*2<sup>nd</sup> Preliminary Consultation*  
**MONTGOMERY COUNTY HISTORIC PRESERVATION COMMISSION**  
**STAFF REPORT**

<b>Address:</b>	5904 Cedar Parkway, Chevy Chase	<b>Meeting Date:</b>	7/11/2018
<b>Resource:</b>	Outstanding Resource Chevy Chase Historic District	<b>Report Date:</b>	7/5/2018
<b>Applicant:</b>	David O'Neil & Laura Billings (David Jones, Architect)	<b>Public Notice:</b>	6/27/2018
<b>Review:</b>	Preliminary Consultation	<b>Staff:</b>	Dan Bruechert

**PROPOSAL:** Garage demolition, non-historic addition removal, hardscape, and landscape alterations

ILLUSTRATIVE SITE PLAN

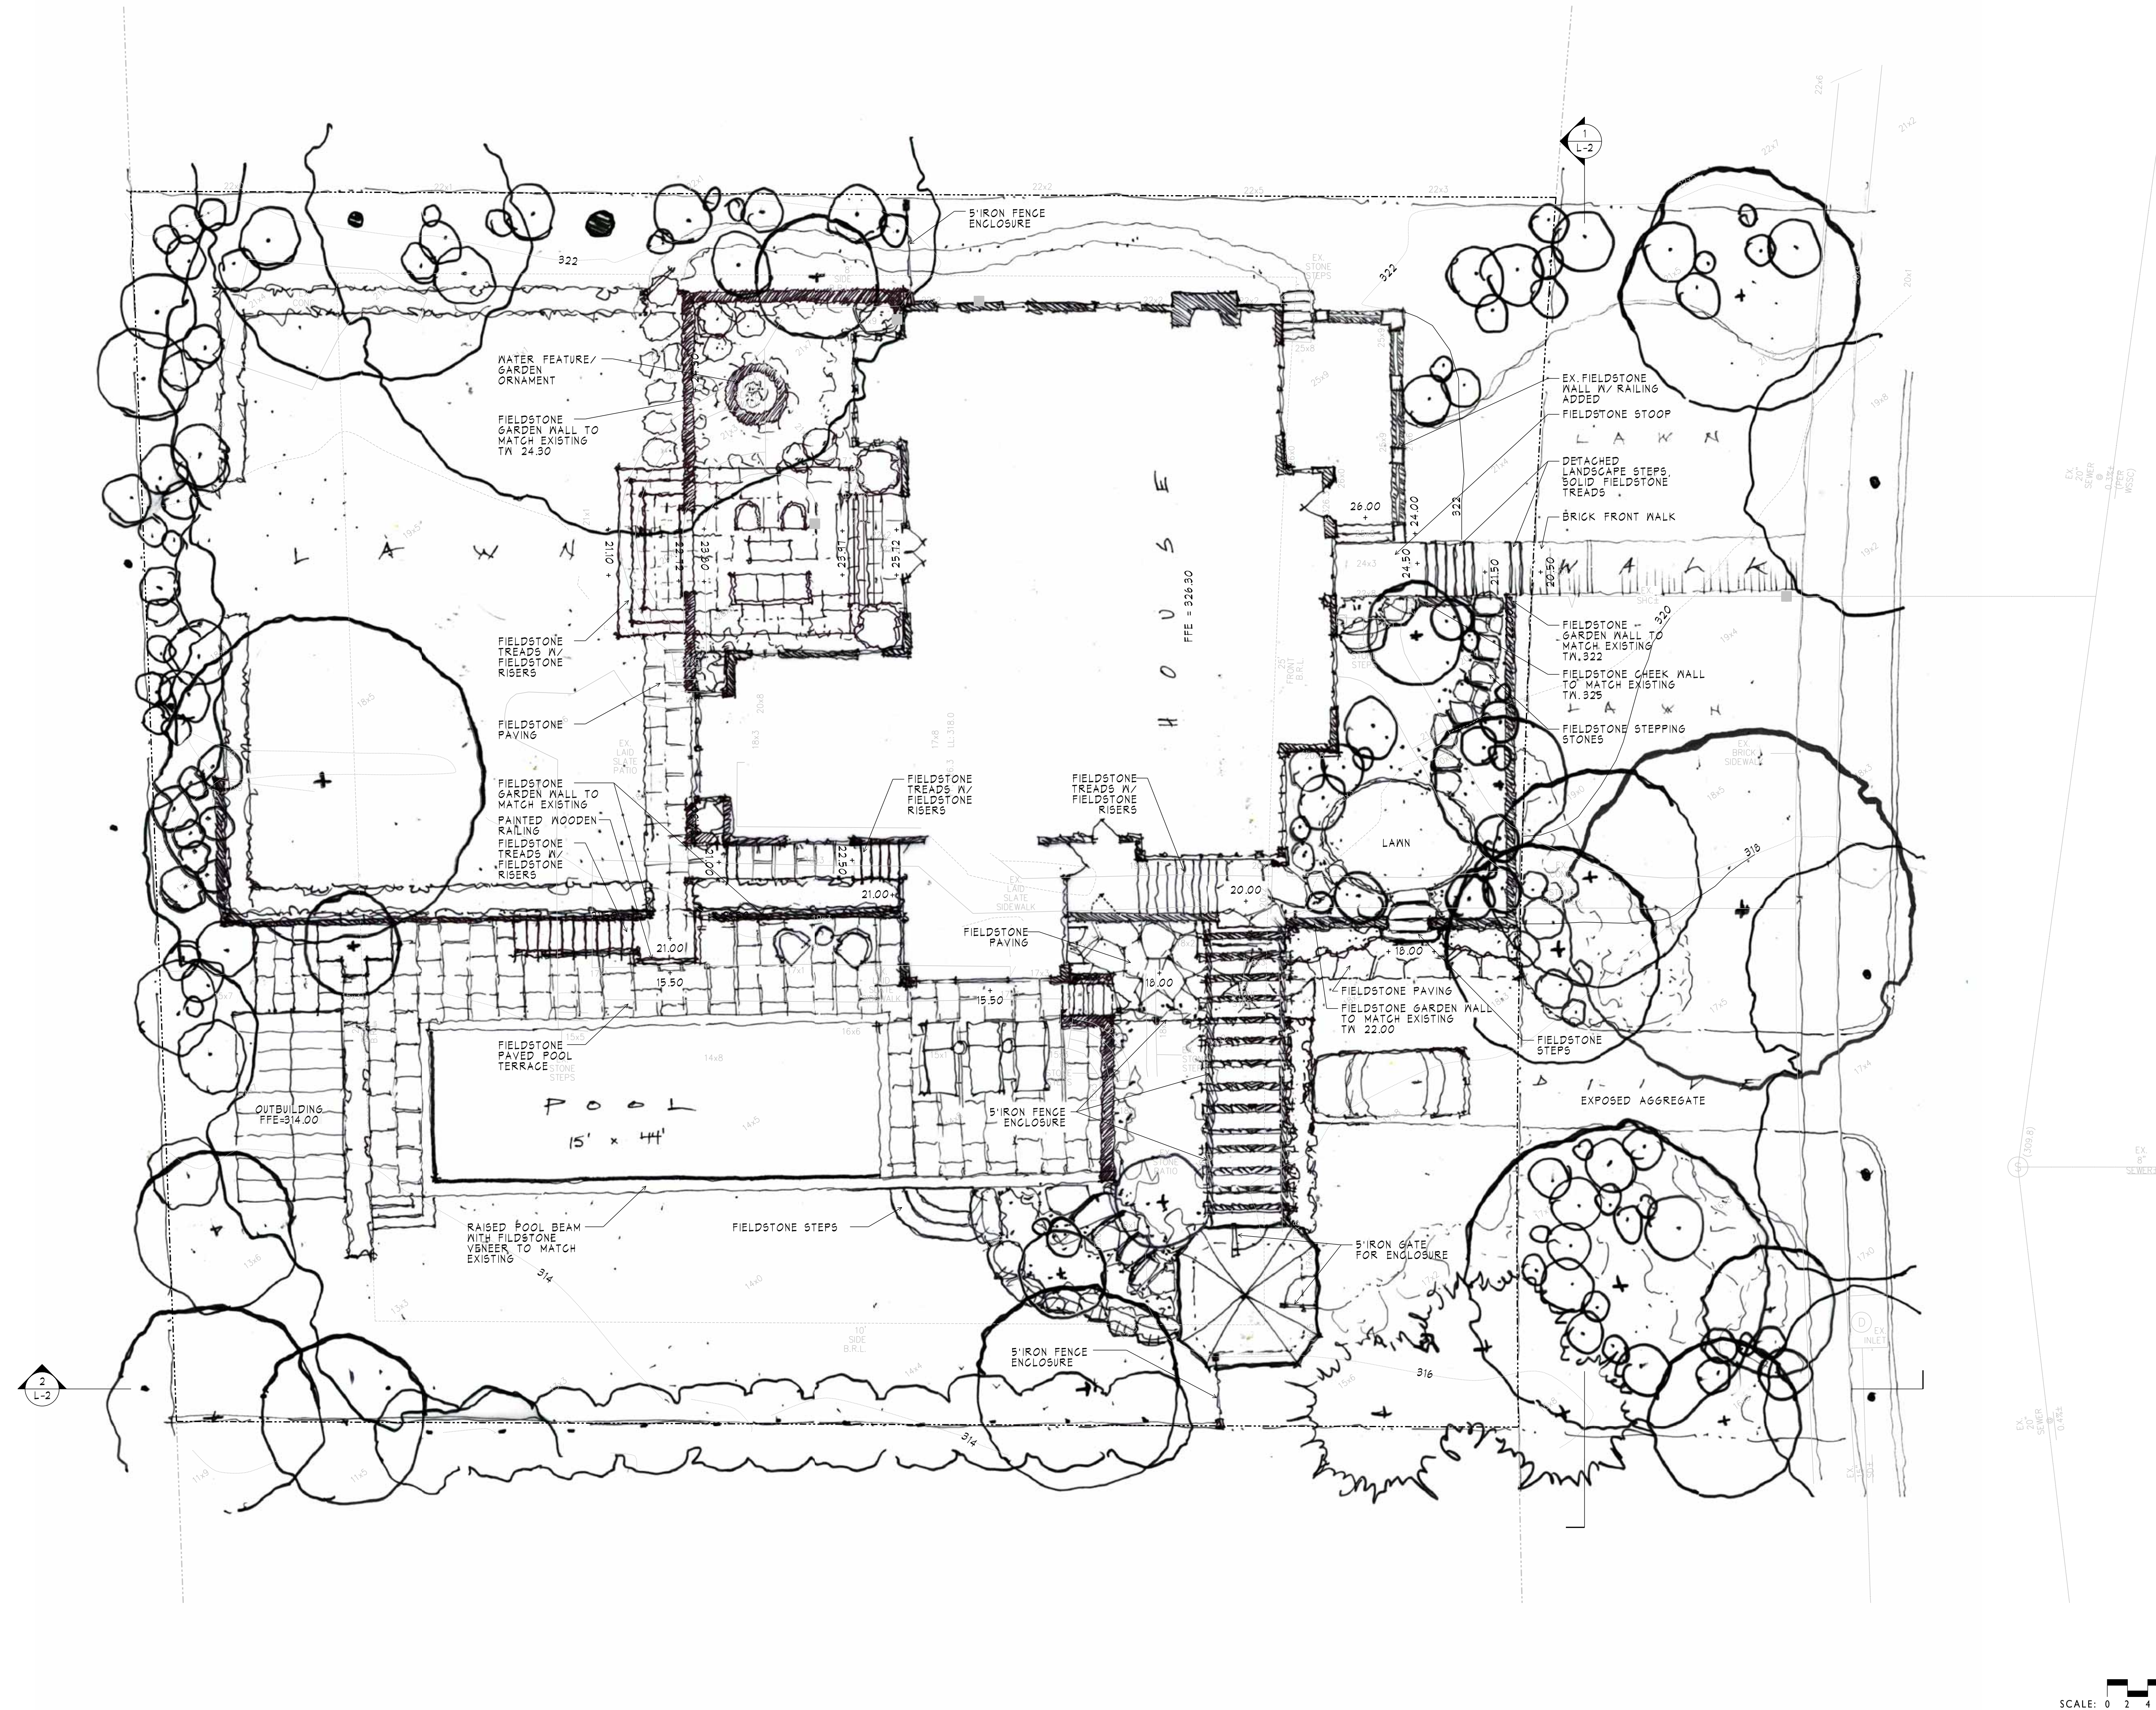
Adjacent to the proposed pool, the applicant proposes to construct a new accessory structure. The only details provided for this new building are shown on the landscape concept drawing (circle: \_\_\_\_). Sufficient details were not provided for Staff to make an evaluation of the design. Based on Staff's observations at the site, this building will likely be largely obscured by the arbor/pergola, but may be minimally visible from an oblique view. As it is a detached accessory building, the *Guidelines* state that it is subject to lenient scrutiny. Staff recommends that the new accessory building take its design cues from the historic garage to ensure design compatibility (per 24A-8(b)(2)), but would welcome an appropriately sized and detailed accessory structure to the rear.

Staff additionally recognizes that in order to comply with code, the applicant will be required to construct a fence surrounding the pool area. Staff finds that a fence with maximum transparency would be most appropriate for the character of the historic building. The applicant's landscape plan indicates that they are proposing a 5' (five foot) tall iron fence. Staff finds this is an

appropriate material, however, the design of the fence was not included in this preliminary consultation. Staff finds that a properly detailed iron fence would be appropriate in this location.

In the rear of the lot the applicant is proposing to construct several new retaining walls. The rendering shows that they will be stone. Staff finds that this is an appropriate material; however, detailed specifications were not provided. Staff request the HPC provide guidance to the applicant regarding new retaining walls and hardscaping. Staff recommends the applicant revise the proposed hardscape based on feedback from the HPC and return with more details and specifications for a second preliminary consultation or HAWP.

STREETSCAPE EXHIBIT

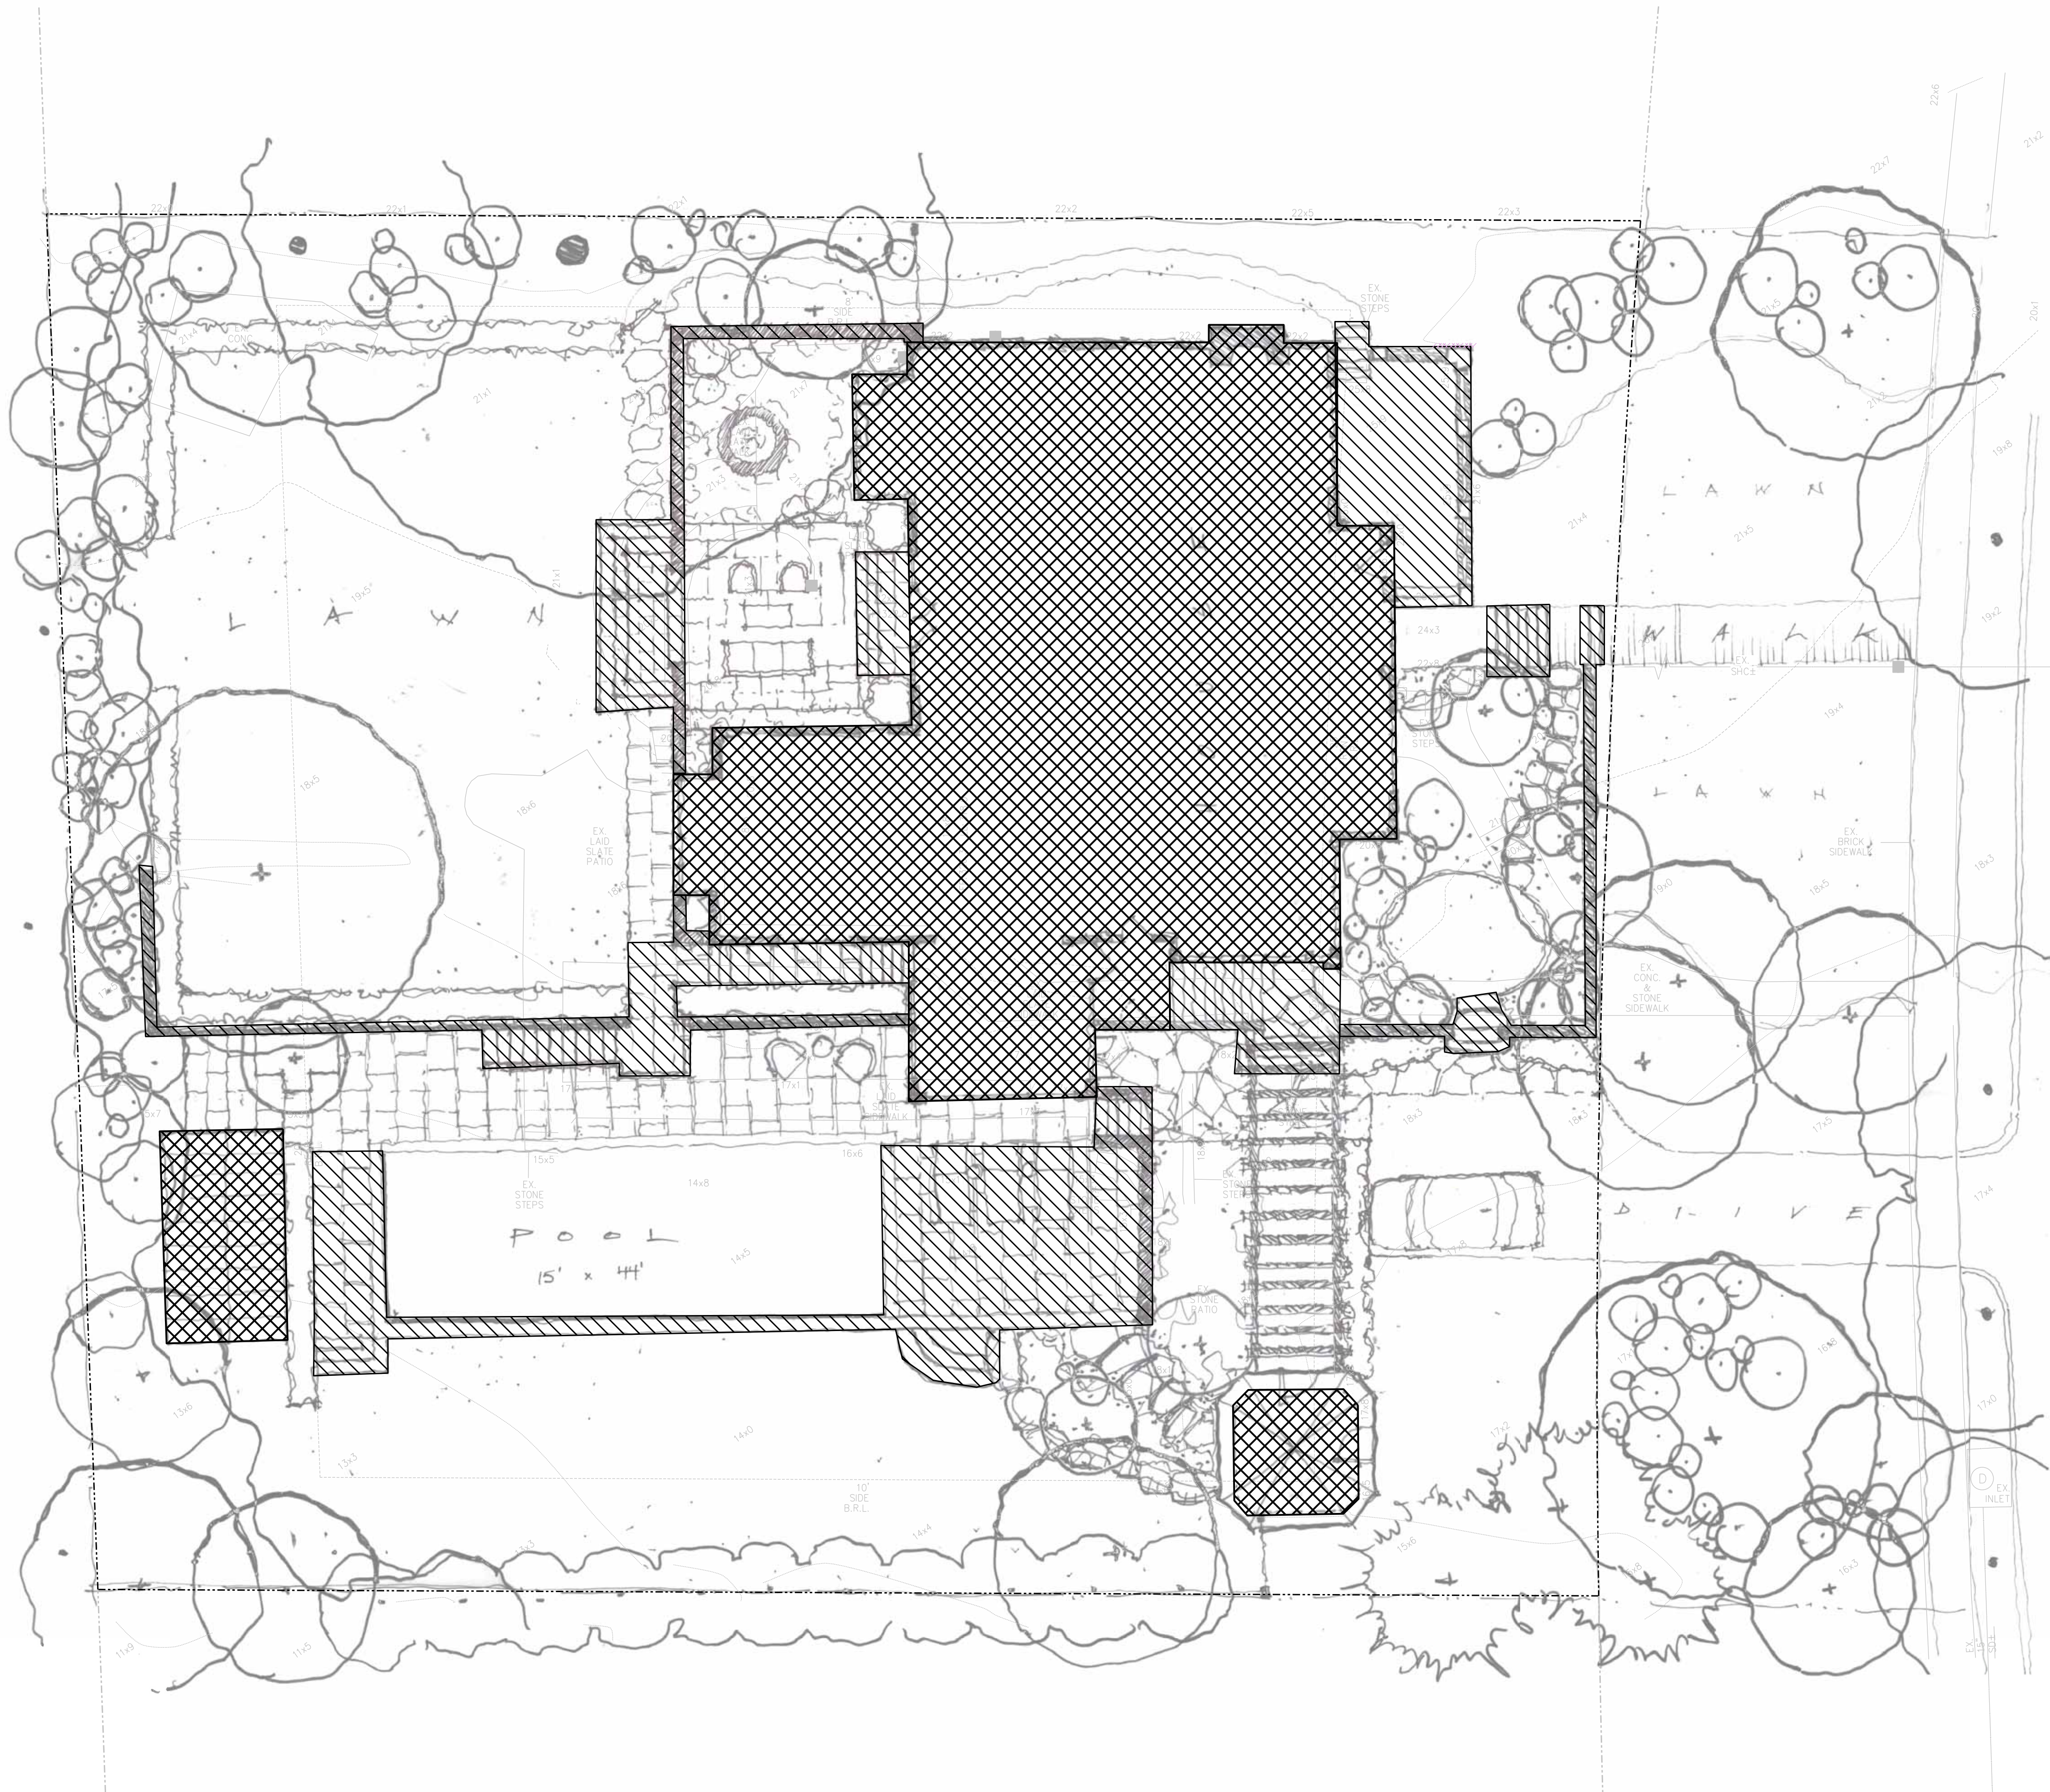
The applicant proposes several alterations to the landscape. The alteration with the largest impact to the streetscape of the building is the proposal to remove the existing asphalt driveway and install landscaping in its place and construct a new drive and parking pad to the immediate left of the historic house. Staff finds that the existing driveway is not sufficient for modern automobiles.

The applicant proposes to construct a new drive and a parking pad approximately 16' (sixteen feet) wide to the left of the historic house. The applicant has included the proposed drive on its site plan and in a rendering comparing an existing view of the house with the new feature. Staff finds that this alteration will alter the historic, but will do so in a manner that the house will still contribute to the historic character of the surrounding district. Several materials were discussed at the Preliminary Consultation; however, the HPC's comments could generally be summed up as a new drive should have a varied texture and color. The HPC expressed some concerns about altering the landscaping at the front of the house, but, did not have enough sufficient detail to provide more feedback. While the rendering is helpful in evaluating the visual impact, this proposal has on the house and surrounding district, there are still two additional details Staff requests be included in an application at the HAWP stage. First, the *Guidelines* state that lot coverage is subject to strict scrutiny in view of the park-like setting of the historic district. Details regarding the amount of driveway materials to be removed from their historic location and amount of new paving must be submitted with the HAWP application for a full evaluation. This information should include existing percentage of lot coverage, amount to be removed, and lot coverage when complete. Second, the applicant should detail any precedent designs within the Chevy Chase Village Historic District. Staff is unaware of any other parking pads installed to the front of houses in Chevy Chase Village and would be more supportive of this proposal if this was a design solution employed elsewhere within the historic district.
